Title:	Response to Notice of Disapproval TA-63 Transuranic Waste Facility Permit Modification Request, Rev. 2, Los Alamos National Laboratory
Author(s):	Bacigalupa, Gian A.
Intended for:	Report Environmental Programs
Issued:	2015-04-07 (rev.1)

SUBJECT: RESPONSE TO DISAPPROVAL, TA-63 TRANSURANIC WASTE FACILITY PERMIT MODIFICATION REQUEST, REVISION 2.0, LOS ALAMOS NATIONAL LABORATORY, EPA ID #NM 0890010515, LANL-11-045

RESPONSE TO
DISAPPROVAL, TA-63 TRANSURANIC WASTE FACILITY
PERMIT MODIFICATION REQUEST
REVISION 2.0
LOS ALAMOS NATIONAL LABORATORY
EPA ID# NM 0890010515
LANL-11-045

FIGURE 55.

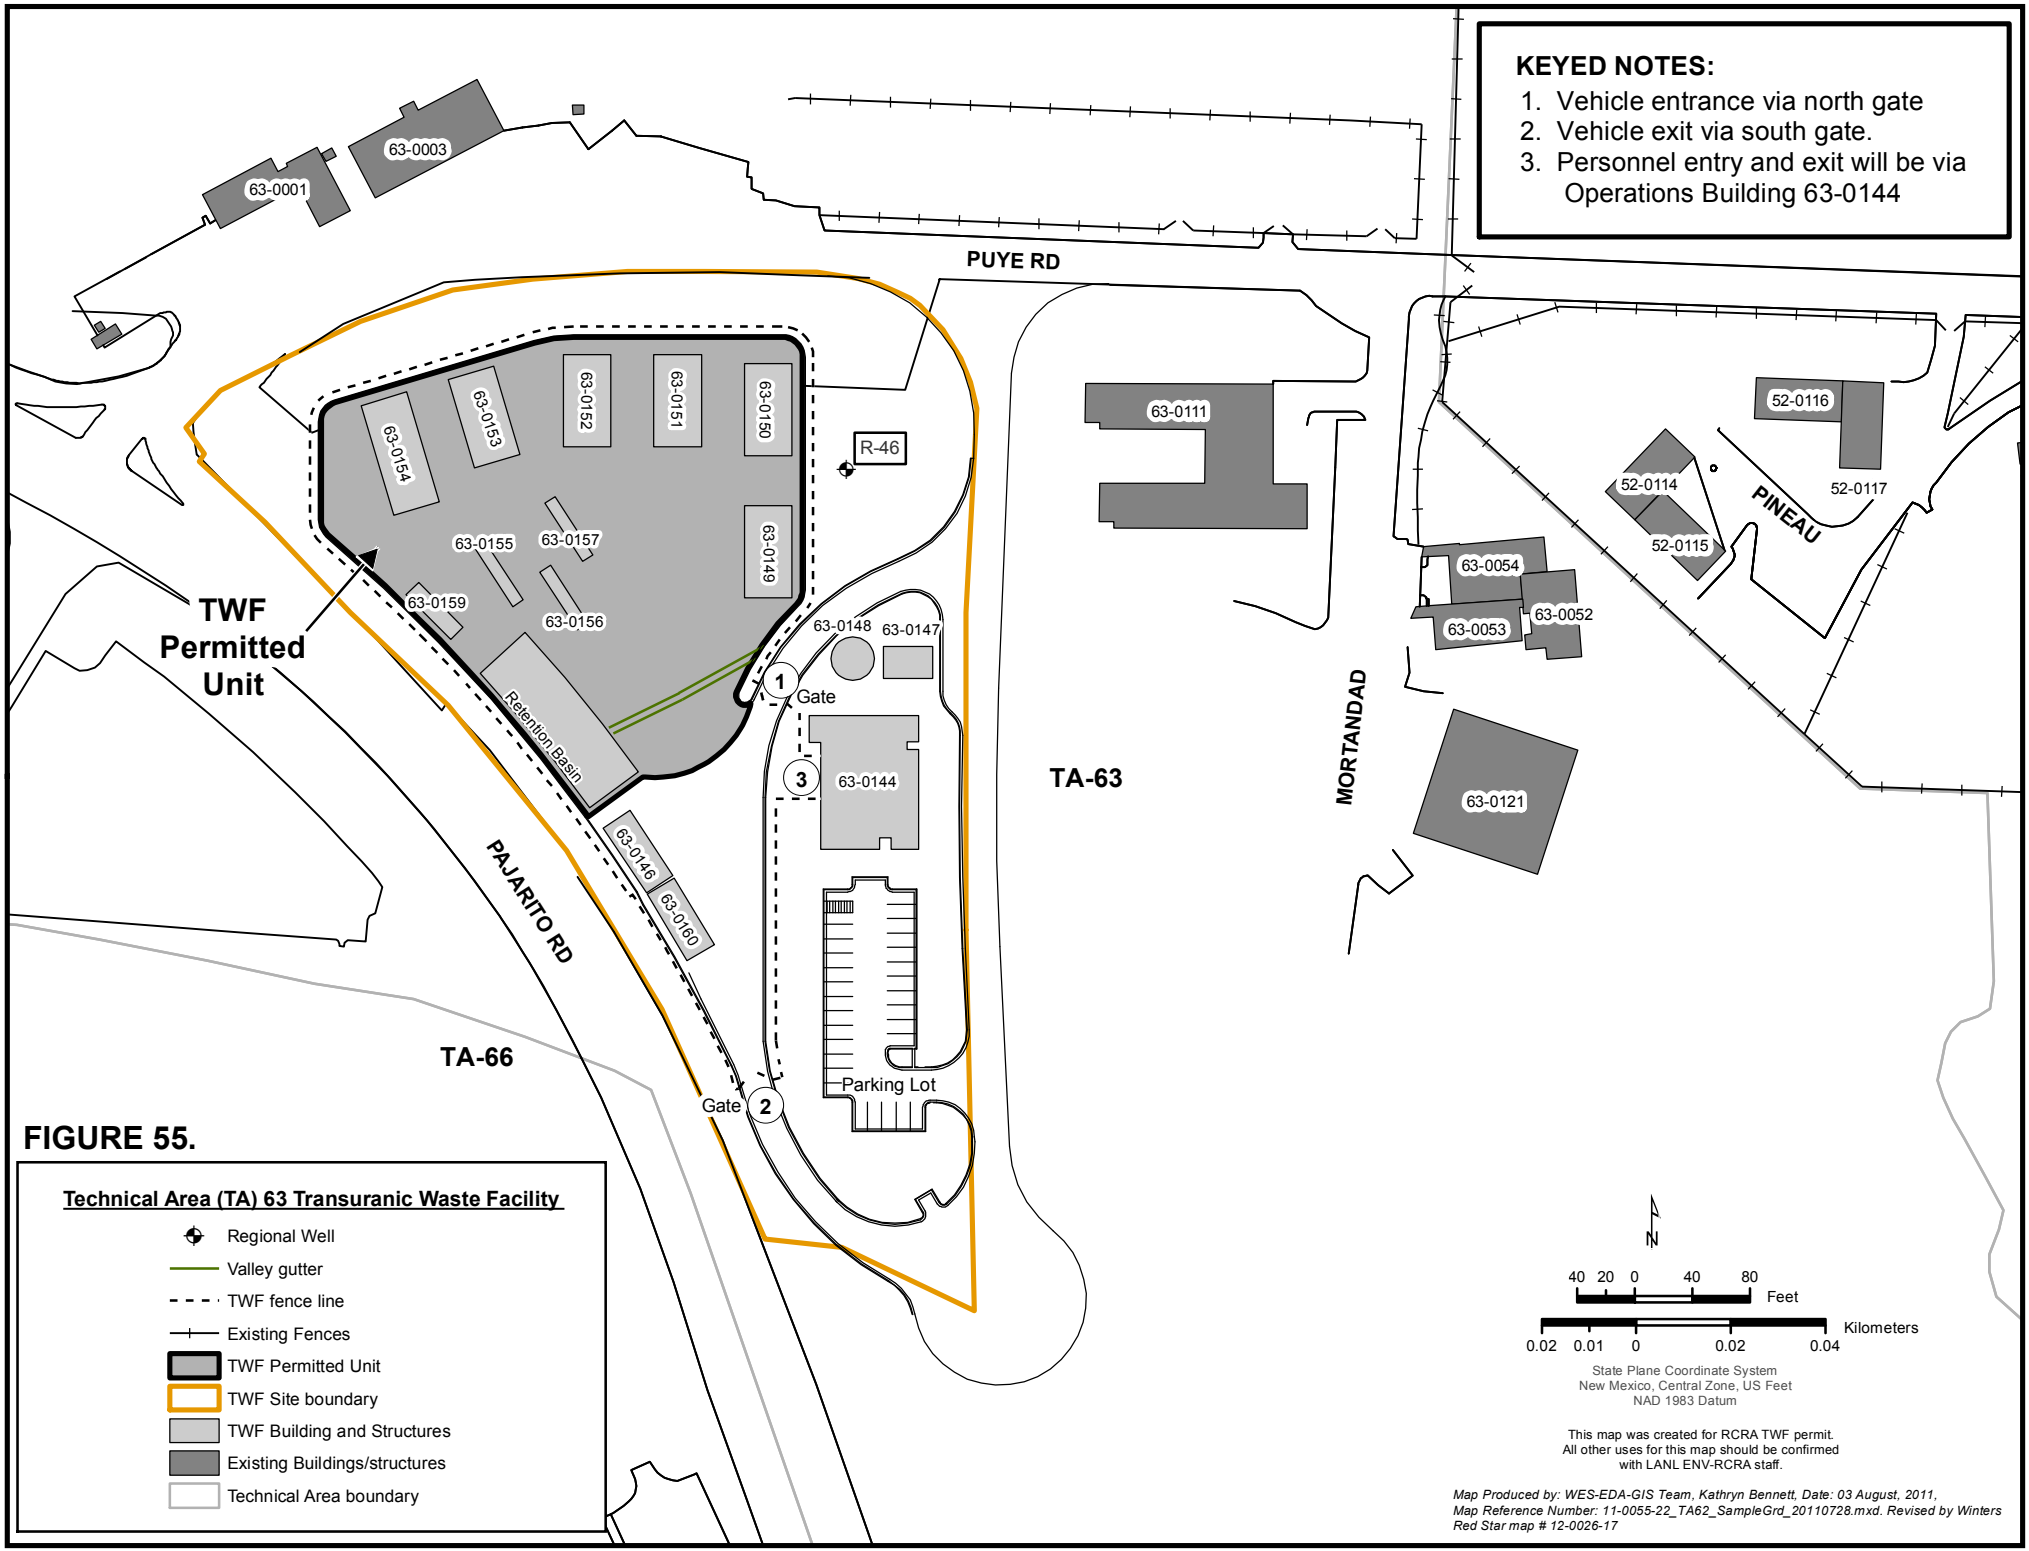
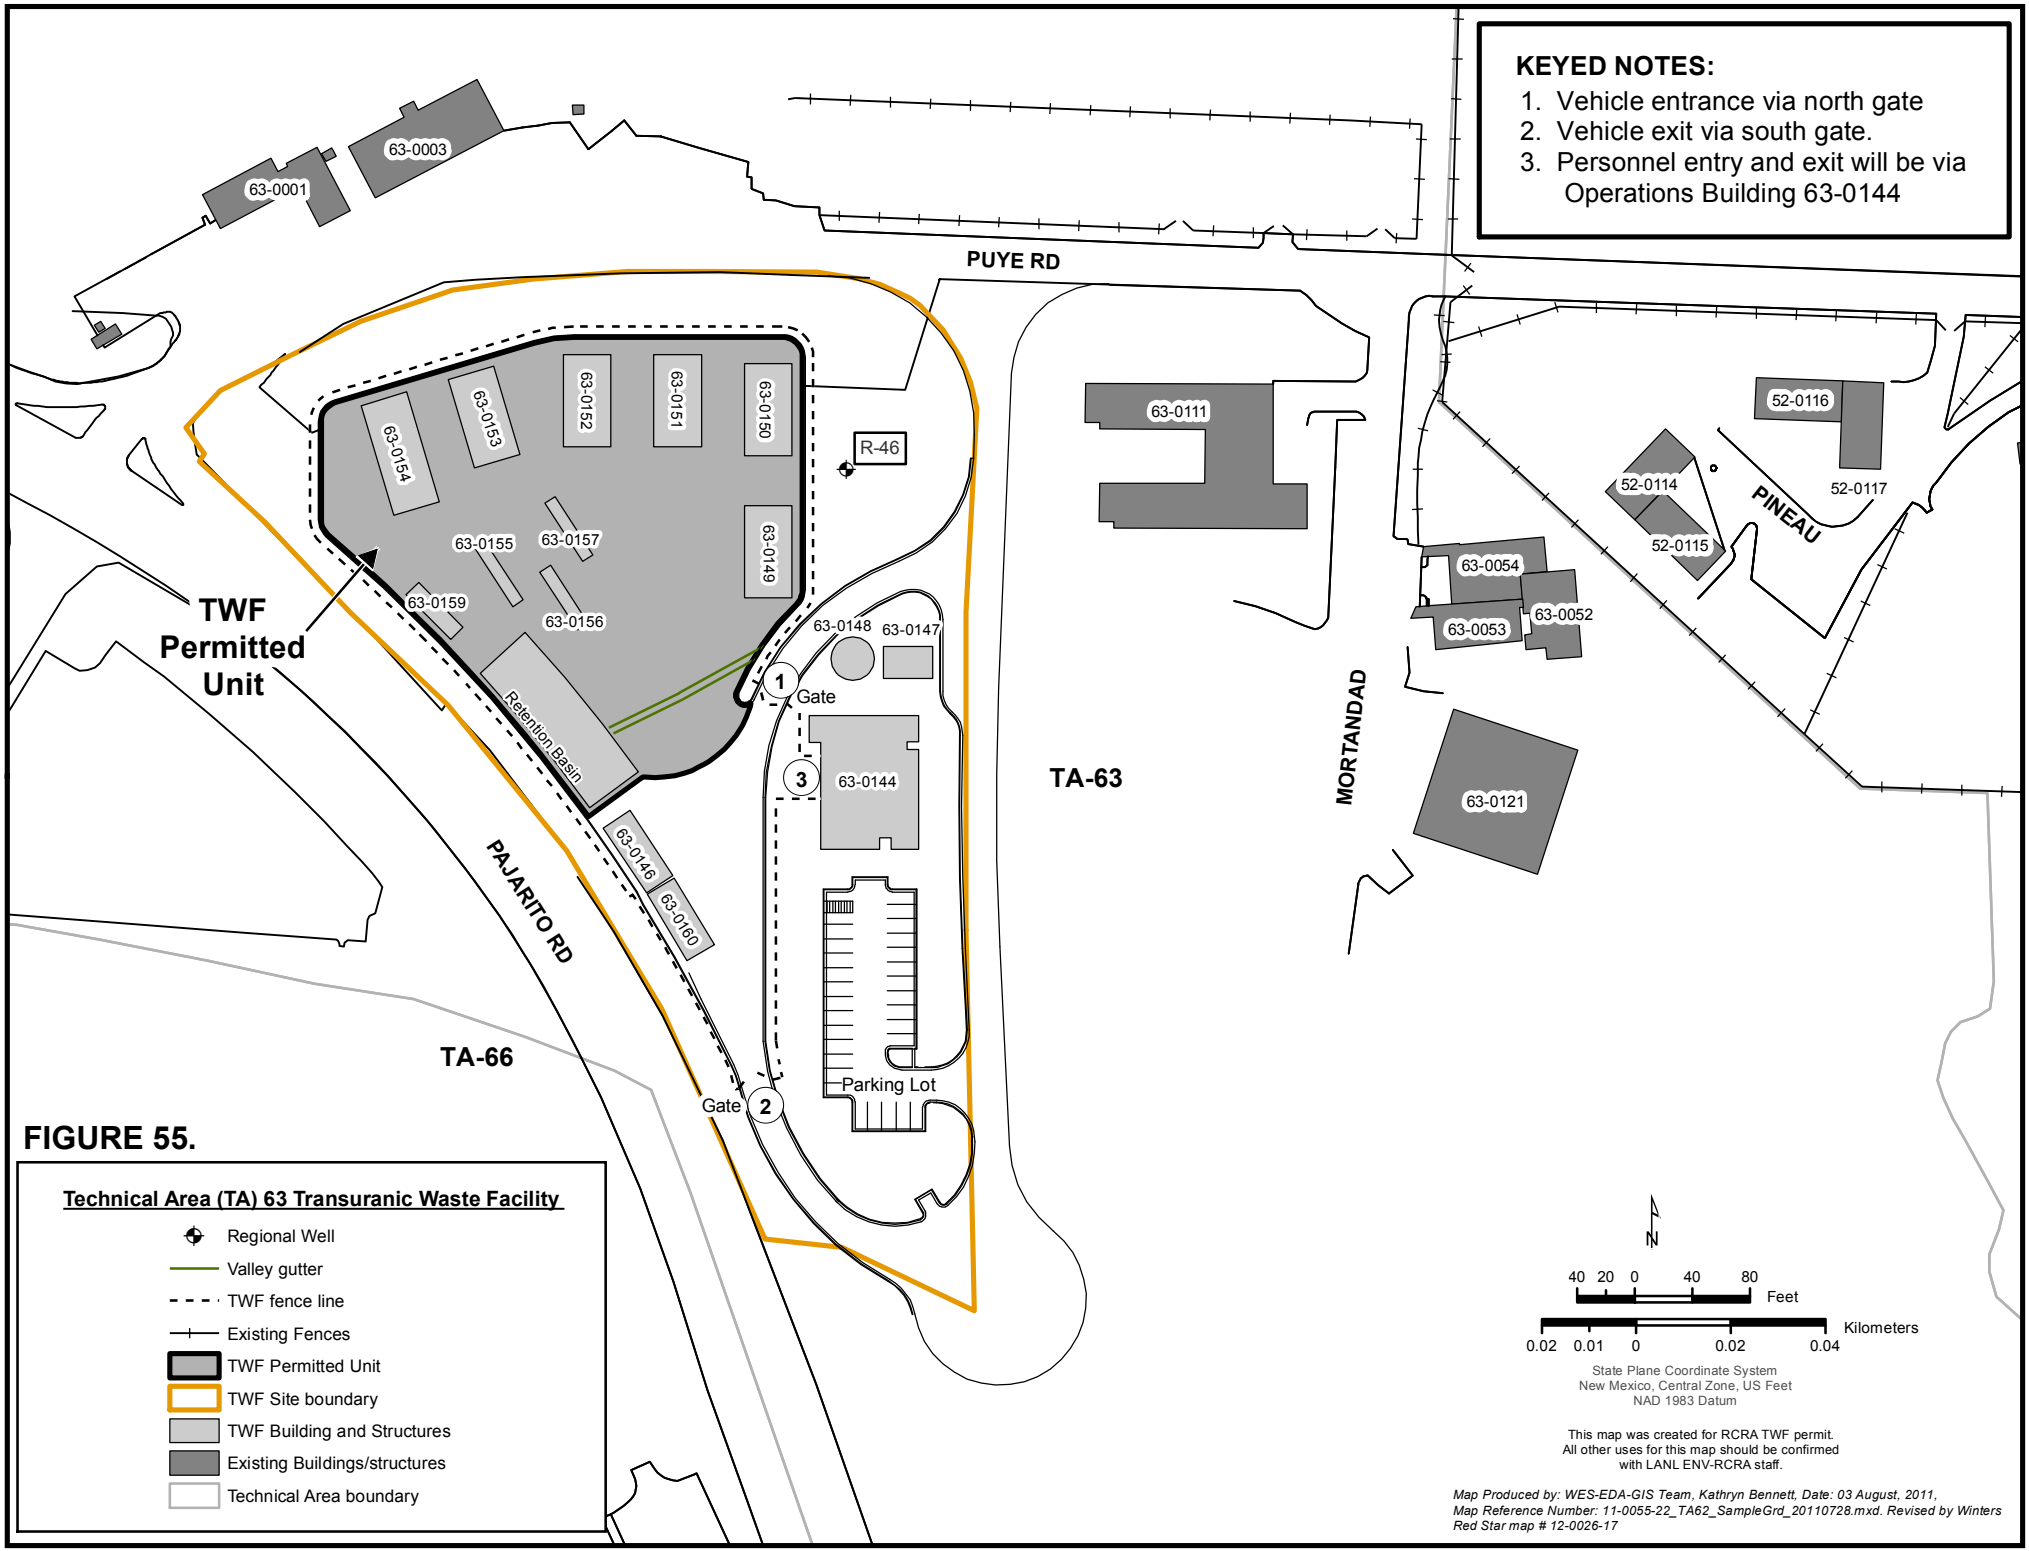
2. 40 CFR 264.176 states: "Containers holding ignitable or reactive waste must be located at least 15 meters (50 feet) from the facility's property line." Permit Part 2, Section 2.8, requires the Permittees to store ignitable and reactive waste "at least 15 meters from the facility boundary defined as the technical area (TA) specific boundary." Although the 15-meter buffer appears to meet the distance requirements in 40 CFR 264.176 and Permit Section 2.8, Figure 2-39 of the PMR indicates that the 15-meter buffer for ignitable and reactive waste extends outside the fence line and at least partially into Pajarito Road, which is not protective of human health and the environment.

"…(4) The Permittees shall ensure that at the TWF, all containers storing hazardous waste with ignitable or reactive components (E.P.A. Hazardous Waste Numbers D001 or D003) are stored no less than 15 meters from the permitted unit's security fence shown in Figure 55 (*see* 40 CFR §264.176)."

(4) The Permittees shall ensure that at the TWF, all containers storing hazardous waste with ignitable or reactive components (E.P.A. Hazardous Waste Numbers D001 or D003) are stored no less than 15 meters from the permitted unit's security fence shown in Figure 55 (see 40 CFR §264.176).

Revised PMR Figure 2-39

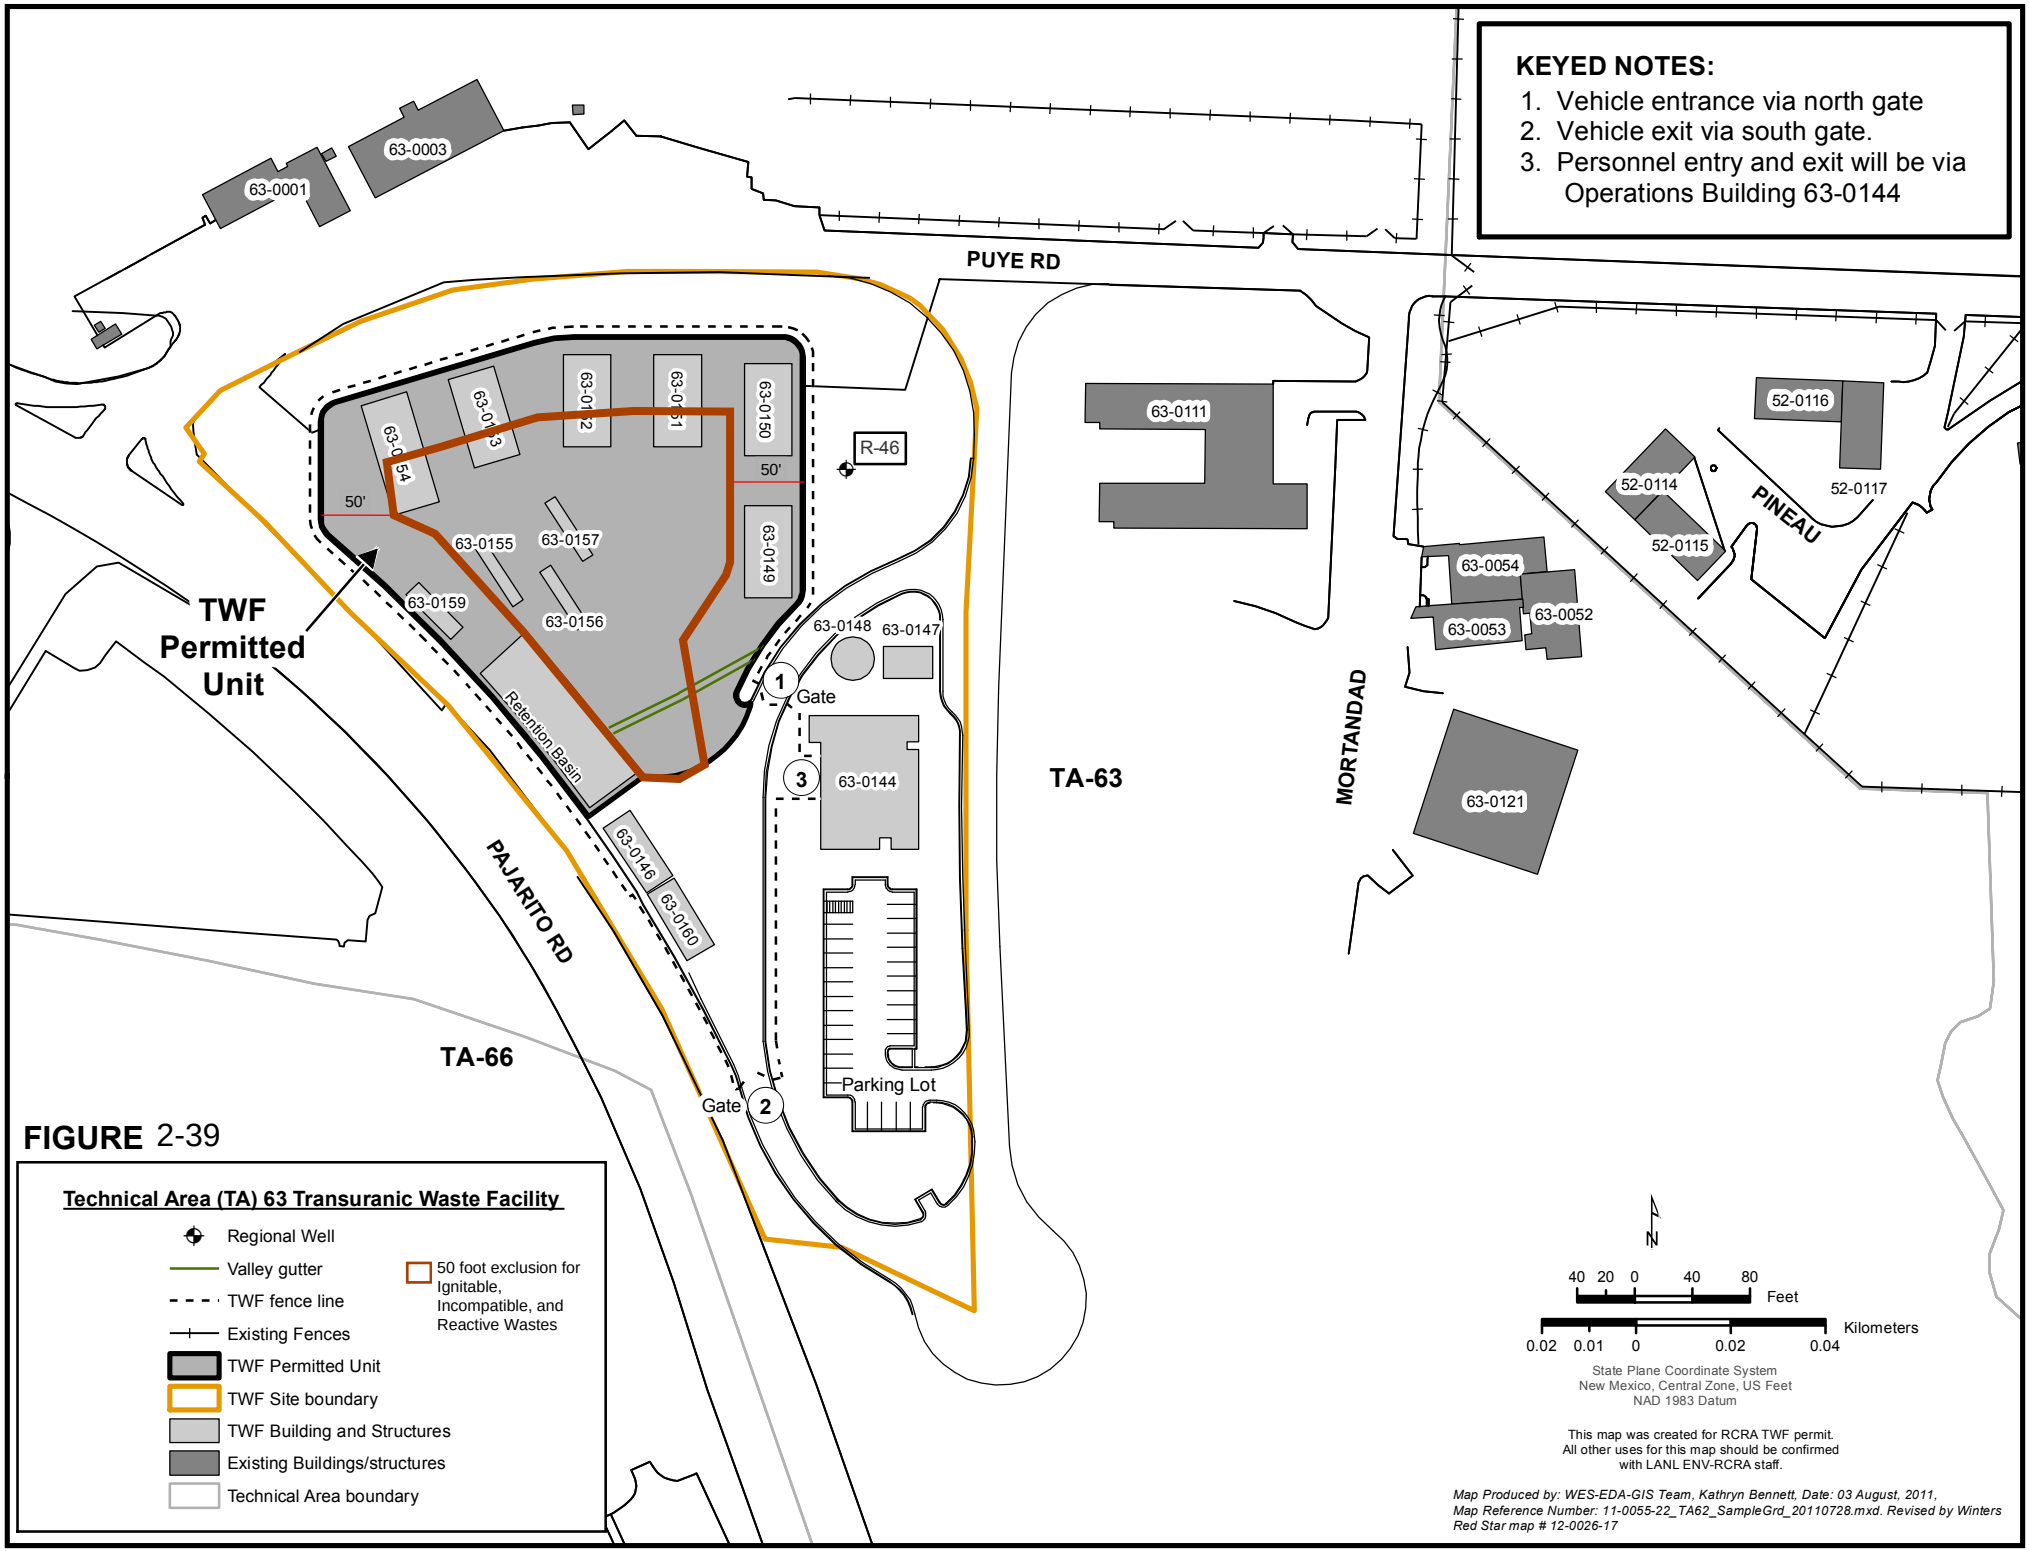
2. *40 CFR 264.176 states: "Containers holding ignitable or reactive waste must be located at least 15 meters (50 feet) from the facility's property line." Permit Part 2, Section 2.8, requires the Permittees to store ignitable and reactive waste "at least 15 meters from the facility boundary defined as the technical area (TA) specific boundary." Although the 15-meter buffer appears to meet the distance requirements in 40 CFR 264.176 and Permit Section 2.8, Figure 2-39 of the PMR indicates that the 15-meter buffer for ignitable and reactive waste extends outside the fence line and at least partially into Pajarito Road, which is not protective of human health and the environment. The purpose for the 15 meter buffer zone is to reduce the potential for exposure to, and/or contact with, ignitable and reactive wastes. Based on the information provided in the PMR, it is conceivable that uninformed persons could get within a few feet of ignitable or reactive waste stored within the proposed 15 meter buffer. Revise the PMR and propose Permit language that requires a 15 meter buffer between areas where ignitable and reactive waste will be stored and the TWF fence line.*

Revise the PMR and propose Permit language that requires a 15 meter buffer between areas where ignitable and reactive waste will be stored and the TWF fence line.

The Permittees acknowledge that the 15 meter buffer proposed in Figure 2-39 of the PMR, Revision 2 projects onto the side of Pajarito Road. It is unlikely that the risk of exposure to or contact with ignitable or reactive waste stored at the TWF will occur due to an inability for personnel to proceed beyond the security fence, the setback of the storage buildings from the fence, the non-flammable nature of the concrete pad and metal storage buildings, and because almost all waste stored at the site will be within the storage buildings. The percentage of ignitable or reactive waste stored at the facility will also be relatively small.

However, the Permittees do not believe that the addition of this permit condition will necessarily upset storage arrangements at the TWF for the small quantity of such waste needing storage. A 15-meter buffer zone from the security fence line is proposed within the TWF storage unit. No ignitable or reactive TRU mixed waste will be stored within that buffer zone. Figure 2-39 of the PMR has been revised to show the revised boundary.

The text of Section 2.8 of the PMR has been revised to reflect the new 15-meter buffer from the TWF security fence line for the storage of ignitable or reactive waste (see Attachment E). Attachment F of this response also includes a revised Figure 2-39 for the TWF PMR that incorporates the new buffer zone.
